## **ADDENDUM NO. 1**

### **TO SPECIFICATIONS AND PLANS FOR THE CITY OF TRAVERSE CITY**

#### **WEST END BEACH PARKING LOT REPAIR AND MDNR GRANT #TF22-0162 BATHROOMS PROJECT**

ISSUED: February 13, 2025

ALL UTILITIES AS SHOWN ARE APPROXIMATE LOCATIONS DERIVED FROM GROUND MEASUREMENTS AND AVAILABLE RECORDS. THEY SHOULD NOT BE INTERPRETED TO BE EXACT LOCATION NOR SHOULD IT BE ASSUMED THAT THEY ARE THE ONLY UTILITIES IN THE AREA.

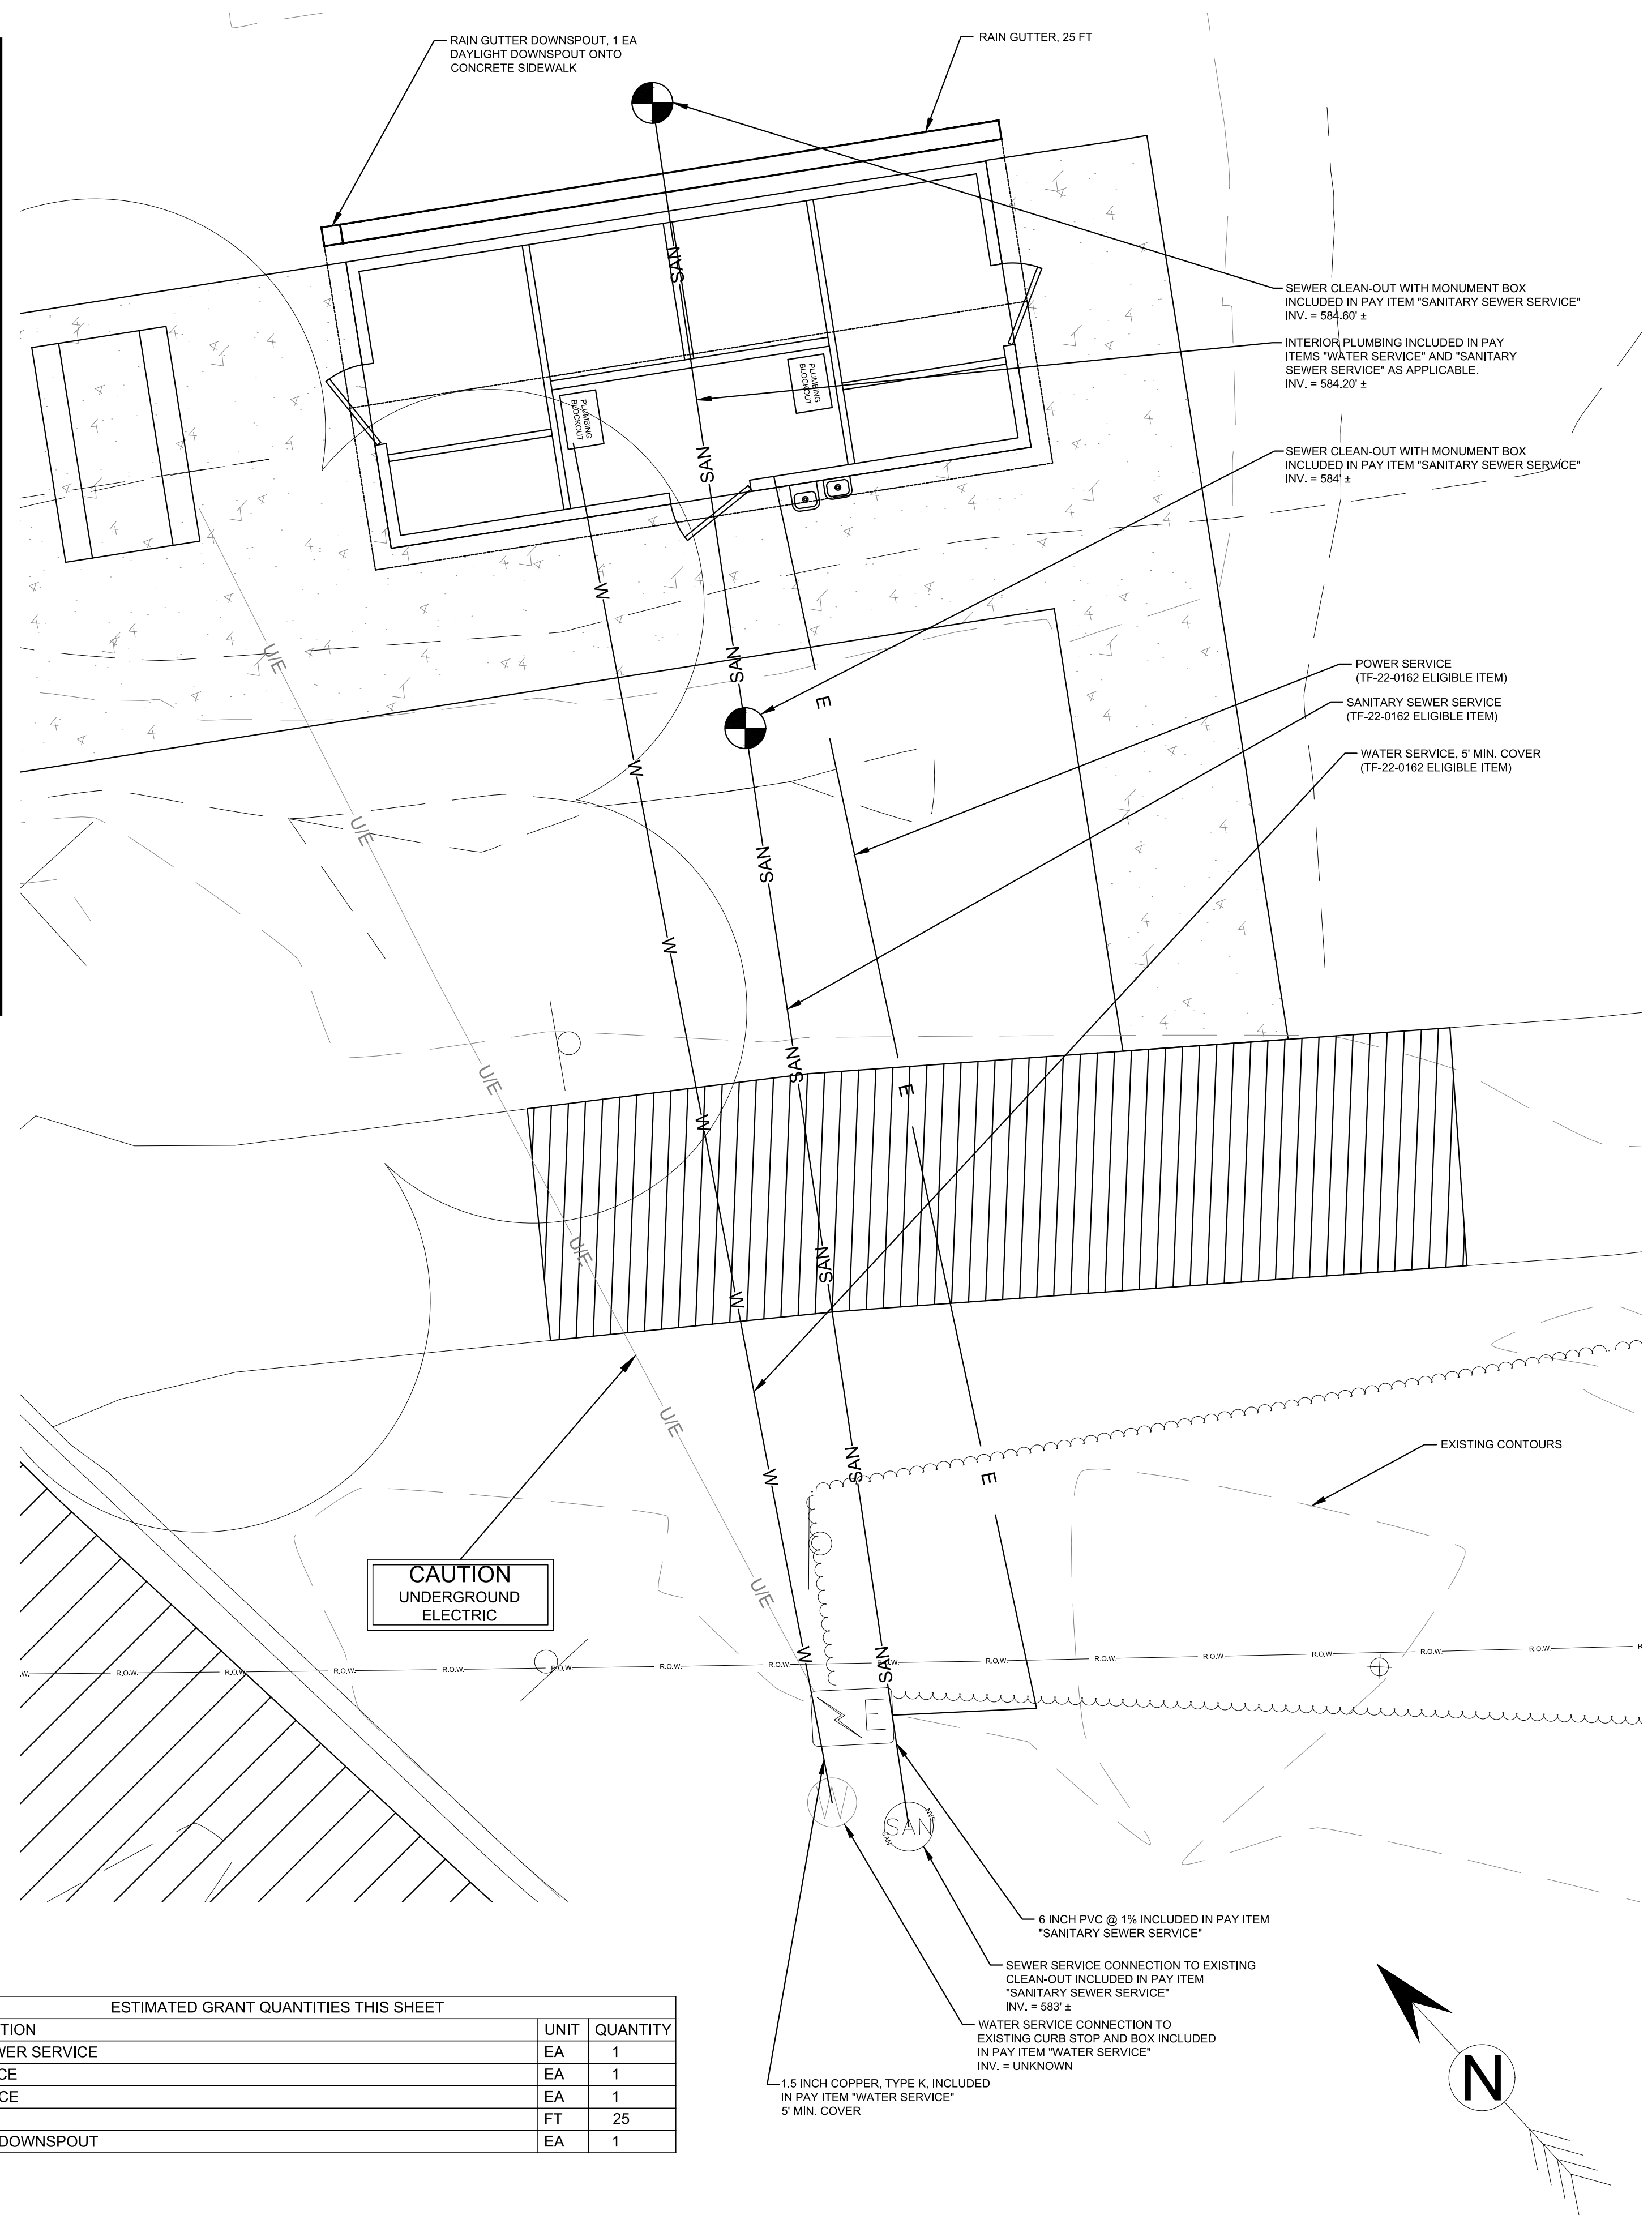
1. Sheet 3
  - a. Added Granular Material, CI II to slope restoration area.
  - b. Casting symbol at CB-3266 location has been removed.
  - c. Added note clarifying extents of thickened edge sidewalk.
2. Sheet 5
  - a. Added Granular Material, CI II to slope restoration detail. The sand will be used to supplement the riprap to provide a void free (as much a practical) slope.
  - b. Called out Geotextile, Separator, Non-Woven, Modified material under the Quarried Rock Steps in the detail.

1. Added the attached special provision for Geotextile, Separator, Non-Woven, Modified (01-13-2025) to the project specifications. This material must be used as shown in the Slope Restoration and Quarried Rock Steps details and will not be paid for separately.
